Data East Pinball, Inc.  
1990 Janice Avenue  
Melrose Park, IL 60160  
Tel: 1-800-KICKERS or Fax: 708-345-0010

## Technical Support

RE: Last Action Hero/Jurassic Park - Flipper Return Springs

**(Figure 1)**

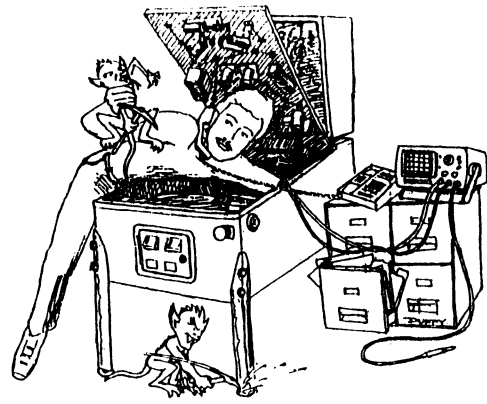
**Symptom:** When flipper is energized it does not return to its rest position after releasing the flipper button.

**Problem:** Flipper return spring has broken off the spring bracket (FIG. 1). We have found a number of these machines which have had the end of the spring crimped to the spring bracket to secure it from popping off. This is not necessary and will cause premature spring failure.

**Solution:** Replace spring (Part No.: 265-5029-02). This is not a modified spring, it is an exact replacement part without the crimp.
